APPLICATION NO.	FILING DATE	FIRST NAMED INVENTOR	ATTORNEY DOCKET NO.	CONFIRMATION NO.
10/590,638	08/23/2006	Dieter Ramsauer	STR-1016/500638.20038	2249
26418	7590	12/22/2009		
REED SMITH, LLP ATTN: PATENT RECORDS DEPARTMENT 599 LEXINGTON AVENUE, 29TH FLOOR NEW YORK, NY 10022-7650			EXAMINER FULTON, KRISTINA ROSE	
			ART UNIT 3673	PAPER NUMBER
			MAIL DATE 12/22/2009	DELIVERY MODE PAPER

Office Action Summary	Application No. 10/590,638	Applicant(s) RAMSAUER, DIETER	
	Examiner KRISTINA R. FULTON	Art Unit 3673

DETAILED ACTION

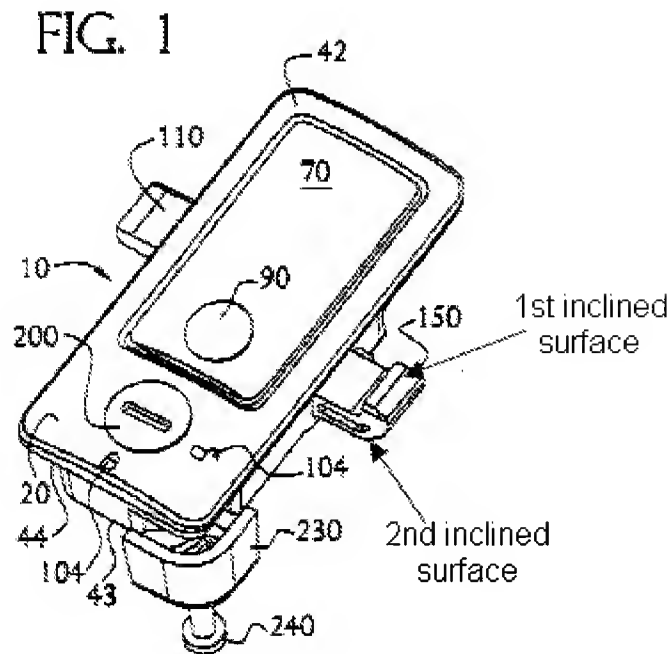
5. Claim 28 requires the holding elements to be in the cylinder 54. Although the figures now show 54 it is unclear from figures 2 and 3 how the cylinder differs from head part. Is the head part of the cylinder?

7. Claim 31 requires the holding elements to be “flexible” yet further in the claim limit the material to a “rigid material”. It is unclear how the holding elements are “flexible” yet made of “rigid metal”. The claims have been examined “as best understood”.

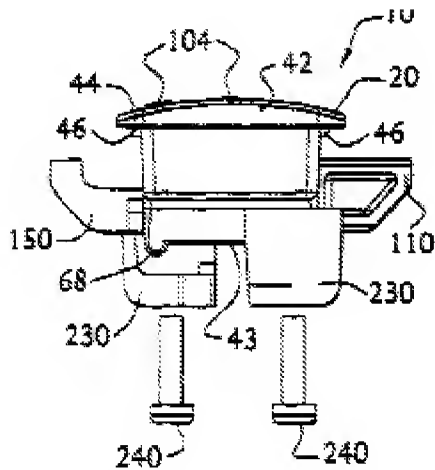
9. Regarding claims 28, 31 and 34, Vickers teaches a latch having a head part (42) arranged outside a thin wall, a body part (20 below 42) which proceeds from the head part and projects through the opening in the mounted position, holding elements (110 and 150) which project from the body part and are flexible in a direction, a free end of the holding elements being provided with an inclined surface (see figure below) for supporting the body part without play on the rim and said free end of said holding elements being further provided with a second inclined surface (see below) for slam action, the body part and the holding elements being separate parts and the holding elements being slides. Please note "as best understood" for the last limitation of claims 28 and 31 and claim 34, Vickers shows a lock cylinder (200) associated with holding elements (110 and 150). If applicant intends to call the head part of the cylinder then please note that applicant's "cylinder" is as much as cylinder as Vickers 10 shown in figure 1.

10. Regarding claim 29 "as best understood", Vickers shows the slides are held against a pressure spring force (198) by a hook arrangement (tabs and slots seen in figures 9 and 10).

11. Regarding claim 31, Vickers teaches the claimed limitations as applied to claim 28 above and further teaches "as best understood" that a slides are held by a spring force (198) and a pin arrangement (tabs and slots of figures 9 and 10). See the Vickers device below.

Applicant's arguments filed 8/18/09 have been fully considered but they are not persuasive. Vickers shows two inclined surfaces as labeled above. Please note that applicant should focus on structural differences as the prior art has the claimed structure and is capable of performing the claimed functional language (the "for" language). Applicant should not rely solely on functional language to define over the prior art.
